APPLICANT: Aspen Hills Redevelopment, LLC

PETITION NO: Z-52

PROPOSED USE: Retail, residential

PLANNING COMMENTS:

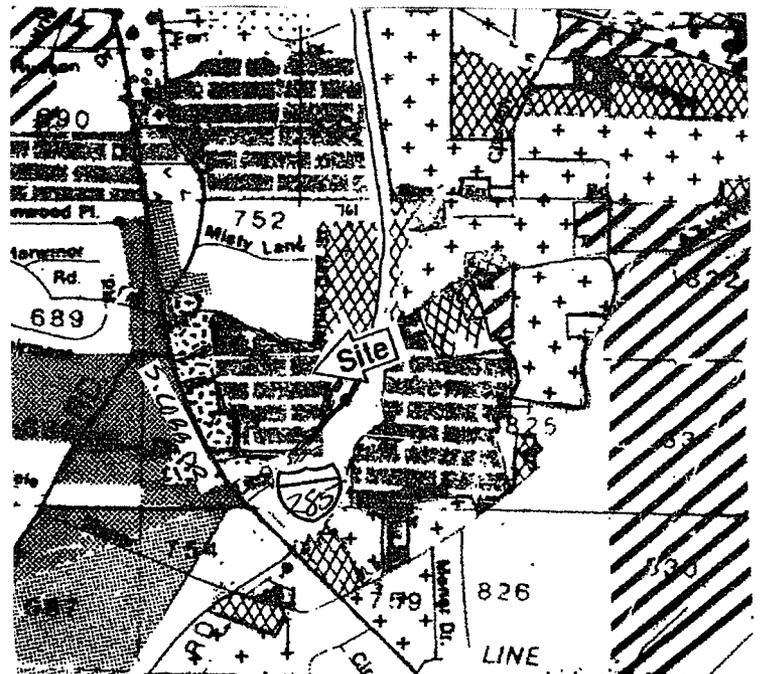
Church Road is classified as a Major Collector and according to the available information, the existing right-of-way does not meet the minimum requirements for this classification. South Cobb Drive is classified as an Arterial and according to the available information, the existing right-of-way does meet the minimum requirements for this classification.

The approach for the full access driveway to South Cobb Drive should include a left turn, a thru lane and a right turn lane.

As necessitated by this development for egress from South Cobb Drive, a deceleration lane will be required at the main access point.

The secondary driveway to South Cobb Drive shall remain right-in/right-out. This access has an existing deceleration lane.

Install sidewalk, curb and gutter along both road frontages.

The applicant will have to verify that minimum intersection sight distance is available. If it is not, the applicant will have to implement remedial measures, subject to approval by the Department, to achieve the minimum requirement of 390'

The western most driveway shall be right-in/right-out with a deceleration lane.

As necessitated by this development for egress from Church Road, a deceleration lane and a left turn lane will be required at each full access point.
